Green and Golden Bell Frog Plan of Management for the M6 Stage 1

Prepared by AMBS Ecology & Heritage Pty Ltd
for CPB Contractors Pty Limited and Ghella Pty Ltd

Final Report

Document Number M6S1-CGU-NWW-EO-PLN-000426

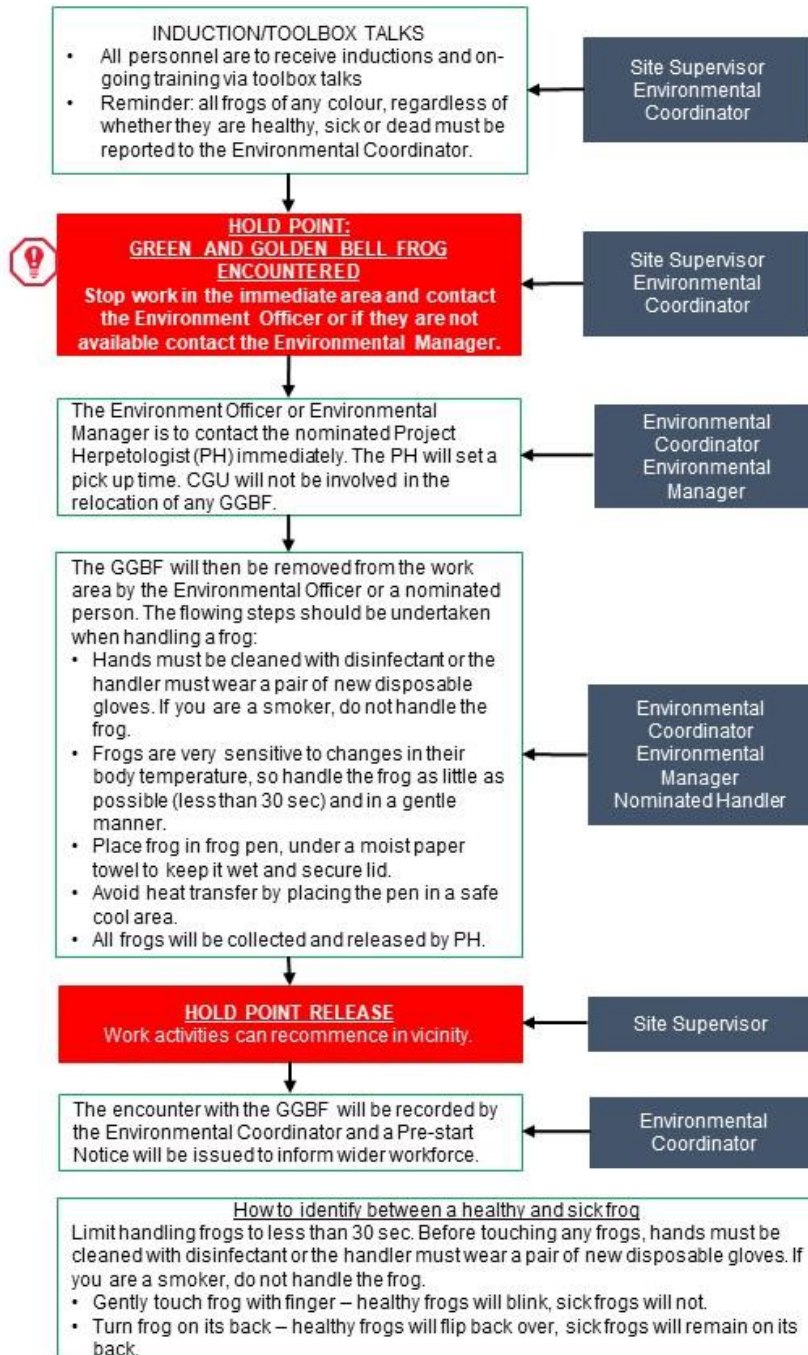
Section	Comment	Response
1.2	Figure 1.3 should be made consistent with Figure 1 of the most recent report <i>Green and Golden Bell Frog Monitoring, Arncliffe, September - November 2020</i> by AMBS Ecology & Heritage, 2021 (shown below), by identifying all of the features referred to in the plan and their boundaries/extents. At the least, all the areas or features mentioned in the plan should be shown. 'Barton Park', the 'Eastern Frog Corridor', the extent (boundary) of the 'Enhancement Area' and the individual ponds within the Enhancement Area are referred to in the plan but are currently not shown in Figure 1.3.	Figure 1.3 has been updated to identify the locations of the features referred to in the plan, with some exceptions and caveats. In relation to the Enhancement Area, the boundary is not shown on Figure 1.3 because the boundary has not been defined, and Figure 1 of the monitoring report shows the approximate area covered during spotlighting surveys, rather than the actual frog habitat, which is a much smaller area. References to the 'Eastern Frog Corridor' have been changed to 'underpass', consistent with the terminology used in the management plans prepared for the M8.
